Access Compliance Report Public Rights-of-Way (Curb Ramps)

Intersection ID: 6172 Main Street: DOUBLE_SPRINGS_CT Cross Street: RUMSTONE_LN Location: W

ADA ID: CD31FF8F618D Ramp Type: Perp Initial Pass/Fail: Fail Overall Compliance: No Severity Score: 8.75

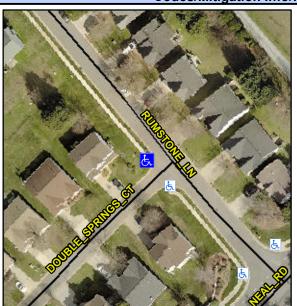
Not Found, R304.5.1

Field Measurements/Component Compilance					
Compliance Description		Data	Compliance Description		Data
N/A	Ramp Length (in)	95.0	Yes	Ramp Slope (%)	7.4
No	Ramp Width (in)	46.0	Yes	Ramp XSlope (%)	1.6
N/A	Flare Type LT	N/A	N/A	Flare Type RT	N/A
N/A	Flare Slope LT (%)	N/A	N/A	Flare Slope RT (%)	N/A
N/A	Flare Traversable LT?	N/A	N/A	Flare Traversable RT?	N/A
N/A	Landing Length (in)	N/A	N/A	DWS Provided?	N/A
N/A	Landing Width (in)	N/A	N/A	DWS Contrast?	N/A
N/A	Landing Slope (%)	N/A	N/A	DWS Length (in)	N/A
N/A	Landing X Slope (%)	N/A	N/A	DWS Full Width?	N/A
N/A	Landing Curb? (Y/N)	N/A	N/A	DWS Offset (in)	N/A
N/A	Shared Landing?	N/A			
N/A	Gutter Ponding?	Yes	N/A	Gutter Slope (%)	N/A
N/A	Gutter Lip Ht (in)	N/A	N/A	Gutter X Slope (%)	N/A
N/A	Painted X Walk1?	No	N/A	Painted X Walk2?	N/A
	X Walk 1 Direction	To SE		X Walk 2 Direction	N/A
N/A	X Walk 1 Width (in)	N/A	N/A	X Walk 2 Width (in)	N/A
	X Walk 1 Slope (%)	0.2		X Walk 2 Slope (%)	N/A

Remove & Replace Entire Ramp.
